**Information technology — Generic coding
of moving pictures and associated audio
information: Systems**

**AMENDMENT 4: Transport of multiview
video over
Rec. ITU-T H.222.0 | ISO/IEC 13818-1**

Reference number
ISO/IEC 13818-1:2007/Amd.4:2009(E)

Figure AMD4.1 – T-STD model extensions for ITU-T Rec. H.264 | ISO/IEC 14496-10 Video with MVC video sub-bitstreams

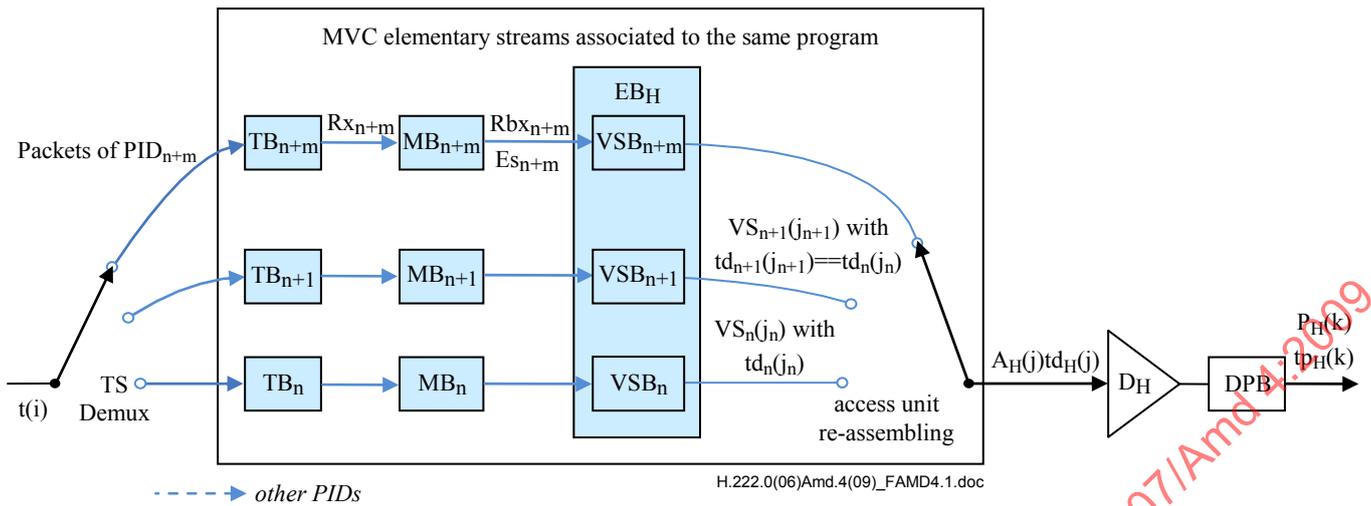
d) After 2.14.3.6, P-STD extensions for SVC, add subclauses 2.14.3.7 to 2.14.3.8:

When there is a set of received video sub-bitstreams and MVC video sub-bitstreams in an ITU-T Rec. H.222.0 | ISO/IEC 13818-1 program, of which dependencies may be signalled in the hierarchy descriptor, as defined in 2.6.7, and when there is at least one of the MVC video sub-bitstreams in the set of received elementary streams having the value of stream_type equal to 0x20, the T-STD model as described in 2.14.3.1 is extended as illustrated in Figure AMD4.1 and as specified below.

The following additional notations are used to describe the T-STD extensions and are illustrated in Figure AMD4.1 above.
